Contribution to 802.3cx

Ulf Parkholm, Ericsson

IEEE 802.3 interim meeting 24th January 2020

Proposed Text to Clarify Tx and Rx Path Data Delay (1 of 3)

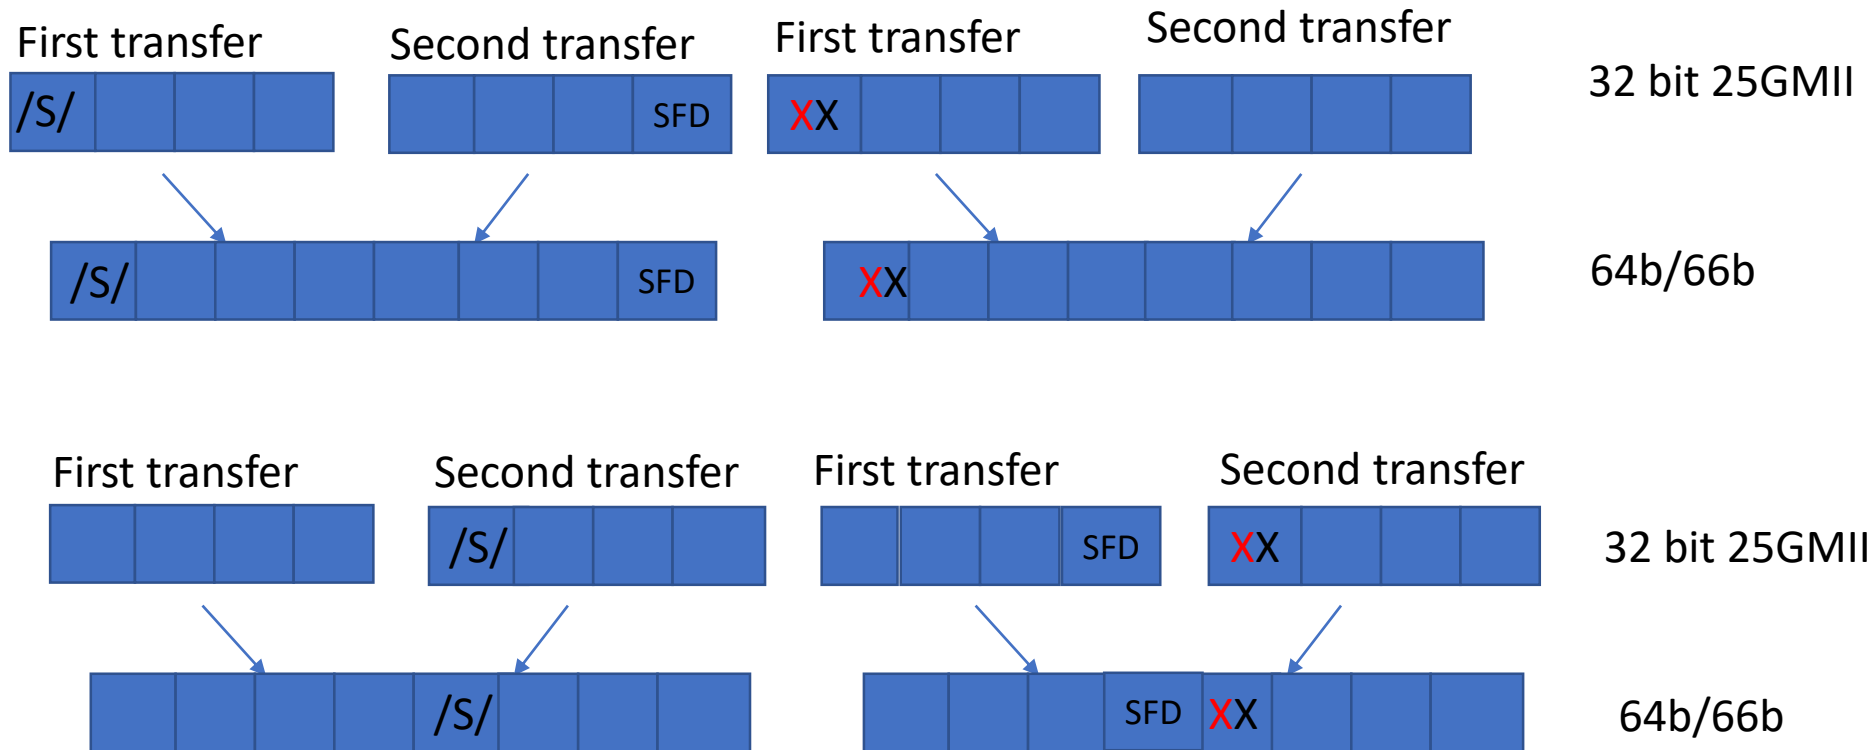
- Redefinition of Time stamp point as proposed by Gorshe and Nicholl with proposed update of Clause 90.7 first paragraph is problematic.
 - In Nicholl Clause 90.7 proposed text:
 - The transmit path data delay is measured from the beginning of the first symbol after the SFD at the xMII input to the beginning of the first symbol after the SFD at the MDI output. The receive path data delay is measured from the beginning of the first symbol after the SFD at the MDI input to the beginning of the first symbol after the SFD at the xMII output.

AM Insert/Delete and Rate Adaptation

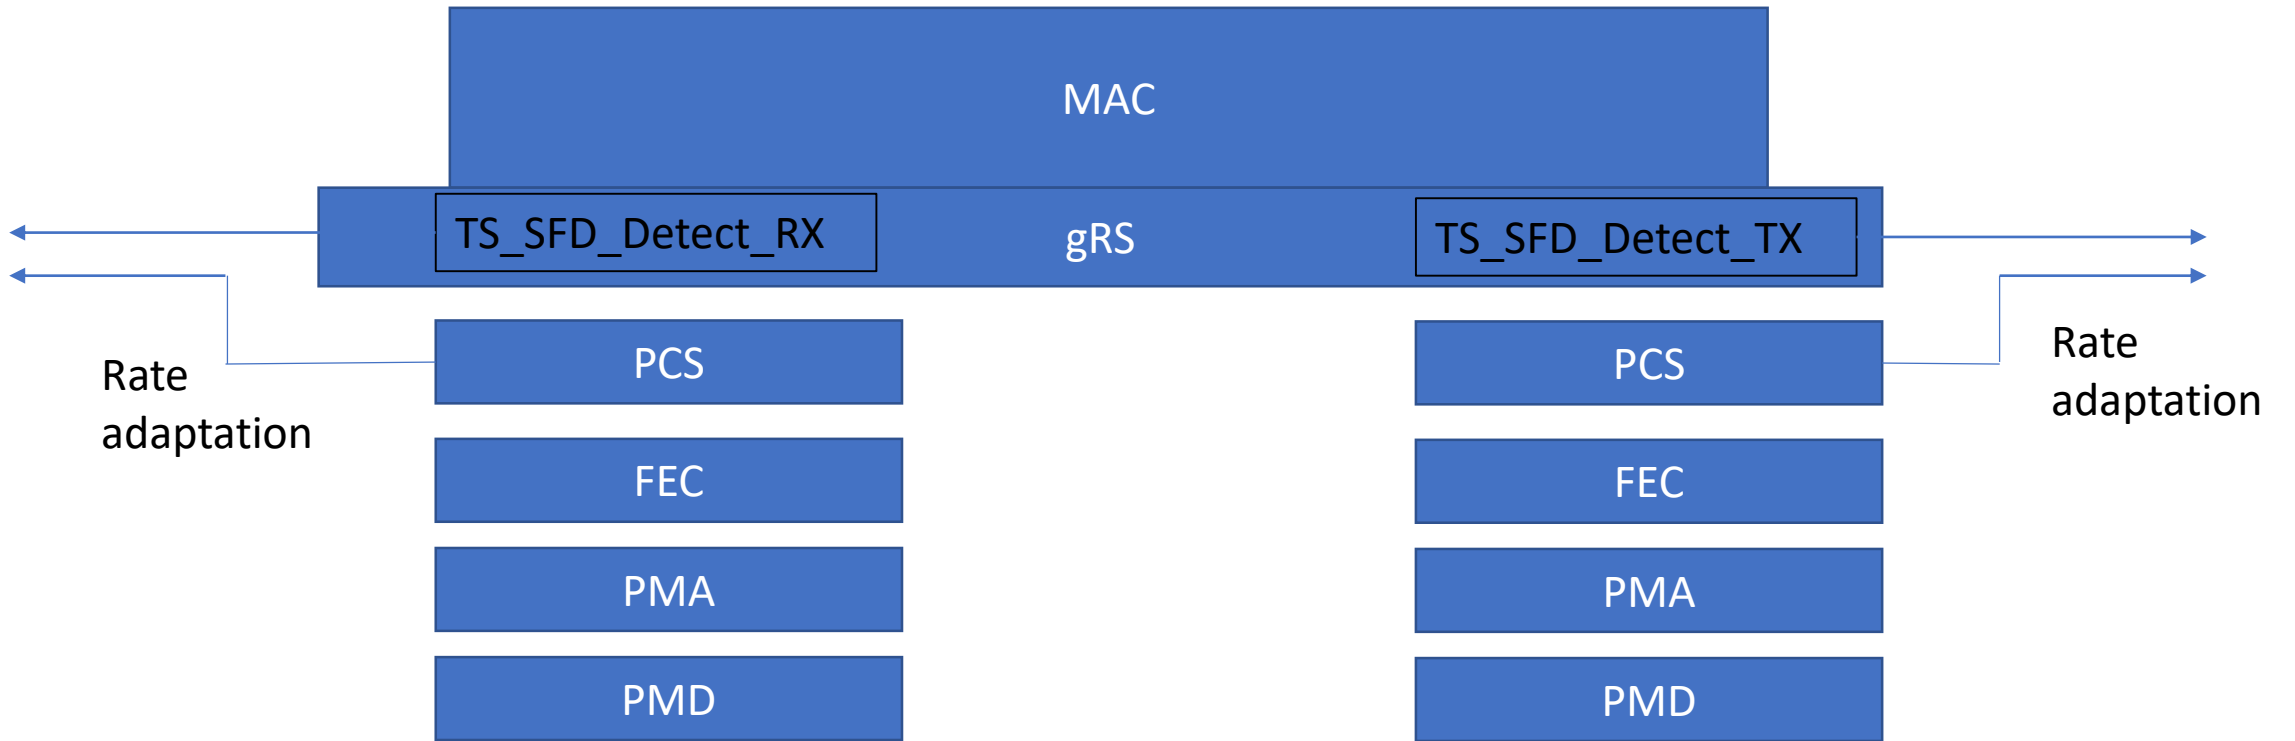
- Agree with Nicholl with proposed text and additions on next page adding clarification that only rate adaptation from AM insertions is applicable, not for CWM.

- In Nicholl Clause 90.7 proposed text to add after existing 90.7 paragraph 2:
 - For a PHY that inserts alignment markers or performs rate adaptation, the transmit path data delay measurement starting point (the beginning of the first symbol after the SFD at the xMII input) should be adjusted to account for alignment marker insertion or rate adaptation that occurs in the PHY (between the xMII input and the MDI output) which impacts the relative location of the beginning of the first symbol after the SFD. Based on this adjustment, the result is a transmit path data delay measurement that appears as if the alignment marker insertion or rate adaptation had been performed before the Tx xMII. Similarly, the receive path data delay measurement ending point (the beginning of the first symbol after the SFD at the xMII input) should be adjusted to account for any alignment markers or rate adaptation that occurred in the PHY (between the MDI input and xMII output) which impacts the relative location of the beginning of the first symbol after the SFD. Based on this adjustment, the result is a receive path data delay measurement that appears as if the alignment marker insertion or rate adaptation had been performed after the xMII.

- Clause 90.7 proposed text to add after existing 90.7 paragraph 2:
 - For a PHY that inserts alignment markers or performs rate adaptation **for the purpose of AM insertion**, the transmit path data delay measurement starting point (~~the beginning of the first symbol after the SFD at the xMII input~~) should be adjusted to account for alignment marker insertion or rate adaptation that occurs in the PHY (between the xMII input and the MDI output) which impacts the relative location of the beginning of the SFD ~~first symbol after the SFD~~. Based on this adjustment, the result is a transmit path data delay measurement that appears as if the alignment marker insertion or rate adaptation **for the purpose of AM insertion** had been performed before the Tx xMII. Similarly, the receive path data delay measurement ending point (~~the beginning of the first symbol after the SFD at the xMII input~~) should be adjusted to account for any alignment markers or rate adaptation **for the purpose of AM insertion** that occurred in the PHY (between the MDI input and xMII output) which impacts the relative location of the beginning of the SFD ~~first symbol after the SFD~~. Based on this adjustment, the result is a receive path data delay measurement that appears as if the alignment marker insertion or rate adaptation **for the purpose of AM insertion** had been performed after the xMII

TSSI interface additions for AM/IDLE insertion/deletion

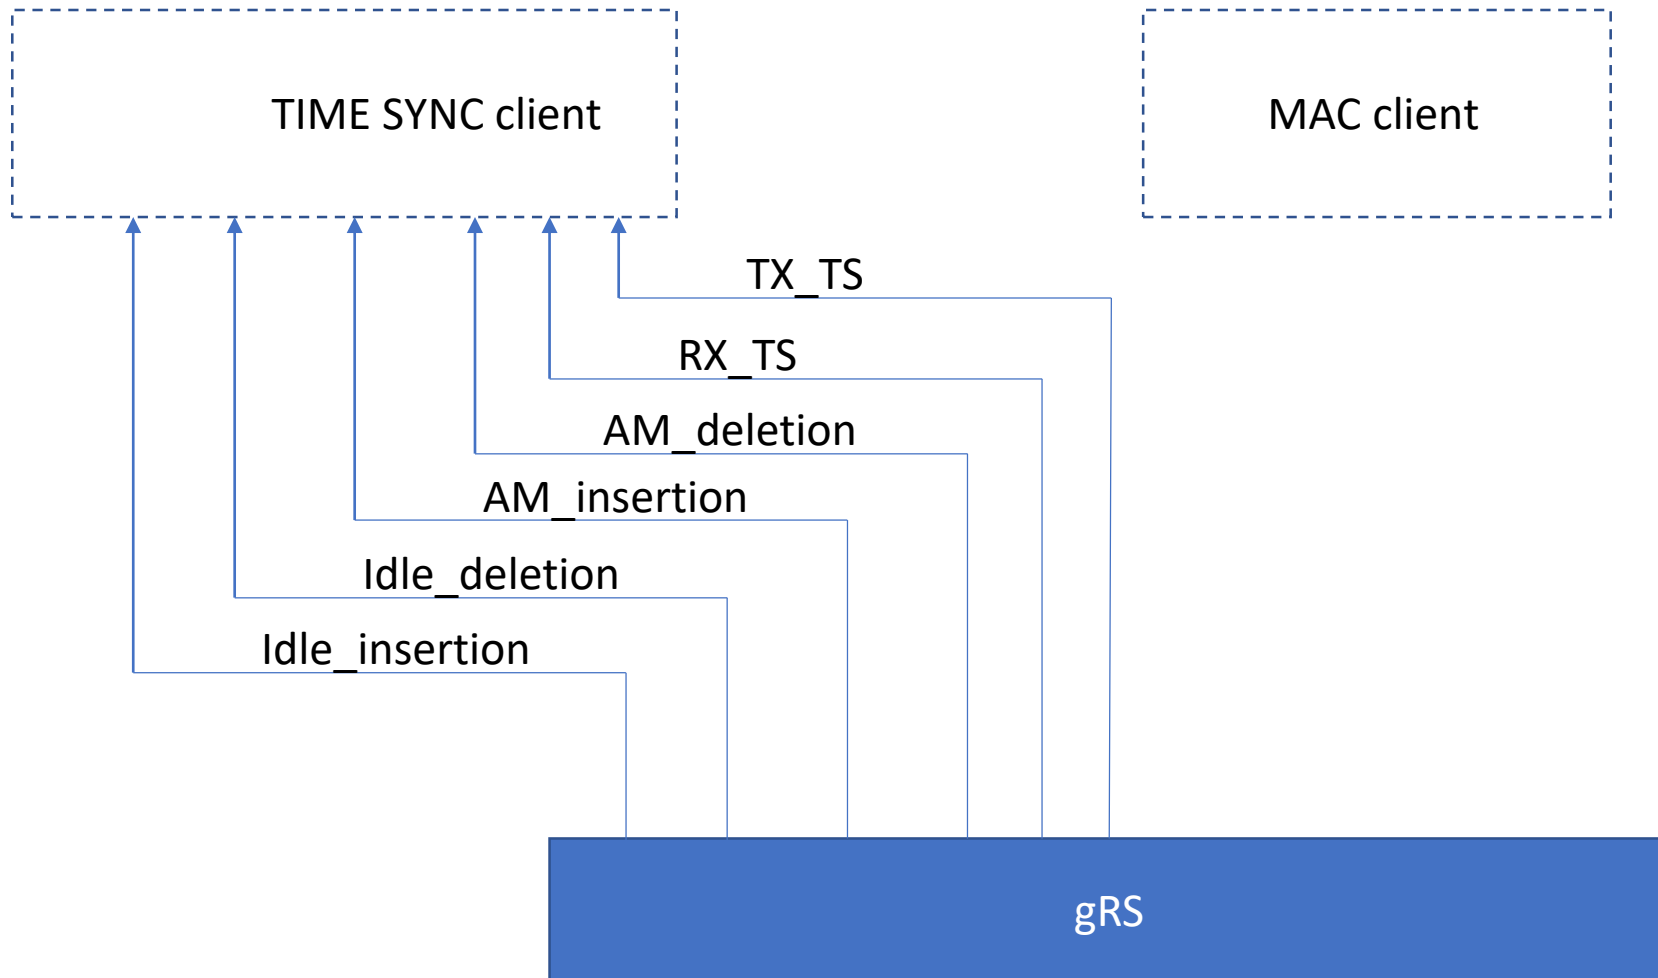
- Clause 90.4.2 defines events for SFD RX and TX detection between gRS and TIME SYNC CLIENT through the TSSI
- With the proposed amendment to Clause 90.7 to account for AM insertion and rate adaptation additional information needs to be passed from PHY to TIME SYNC CLIENT through the gRS layer on a packet-to-packet basis.

- The rate adaptation signals in the TSSI would add to describing the proper handling of AM insertion/deletion and/or Idle.
- These signals would take on the value of TRUE when the corresponding event has been performed within the PHY.
- Possible primitives
 - AM_deletion.indication
 - AM_insertion.indication
 - Idle_deletion.indication
 - Idle_insertion.indication
